# Access Compliance Report

## Public Rights-of-Way

### (Curb Ramps)

Intersection ID: 6085	Main Street: HARTLEY_HILLS_DR	Cross Street: WYNDHAM_POINTE_DR	Location: W
ADA ID: 32785BCBF7BA	Ramp Type: Perp	Initial Pass/Fail: Fail	Overall Compliance: No
Severity Score: 12.5			
Codes/Mitigation Info/Possible Solution		Field Measurements/Component Compliance

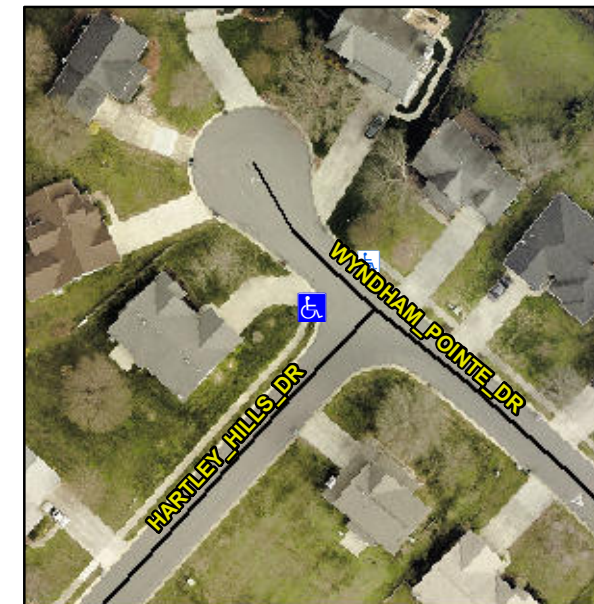
**Not Found, R304.5.3**

Compliance	Description	Data	Compliance	Description	Data
N/A	Ramp Length (in)	49.0	Yes	Ramp Slope (%)	5.2
Yes	Ramp Width (in)	49.0	No	Ramp XSlope (%)	5.8
N/A	Flare Type LT	N/A	N/A	Flare Type RT	N/A
N/A	Flare Slope LT (%)	N/A	N/A	Flare Slope RT (%)	N/A
N/A	Flare Traversable LT?	N/A	N/A	Flare Traversable RT?	N/A
N/A	Landing Length (in)	N/A	N/A	DWS Provided?	N/A
N/A	Landing Width (in)	N/A	N/A	DWS Contrast?	N/A
N/A	Landing Slope (%)	N/A	N/A	DWS Length (in)	N/A
N/A	Landing X Slope (%)	N/A	N/A	DWS Full Width?	N/A
N/A	Landing Curb? (Y/N)	N/A	N/A	DWS Offset (in)	N/A
N/A	Shared Landing?	N/A			
N/A	Gutter Ponding?	N/A	N/A	Gutter Slope (%)	N/A
N/A	Gutter Lip Ht (in)	N/A	N/A	Gutter X Slope (%)	N/A
N/A	Painted X Walk1?	No	N/A	Painted X Walk2?	N/A
	X Walk 1 Direction	To NE		X Walk 2 Direction	N/A
N/A	X Walk 1 Width (in)	N/A	N/A	X Walk 2 Width (in)	N/A
	X Walk 1 Slope (%)	1.4		X Walk 2 Slope (%)	N/A
	X Walk 1 X Slope (%)	5.9		X Walk 2 X Slope (%)	N/A

**Remove & Replace Entire Ramp.**
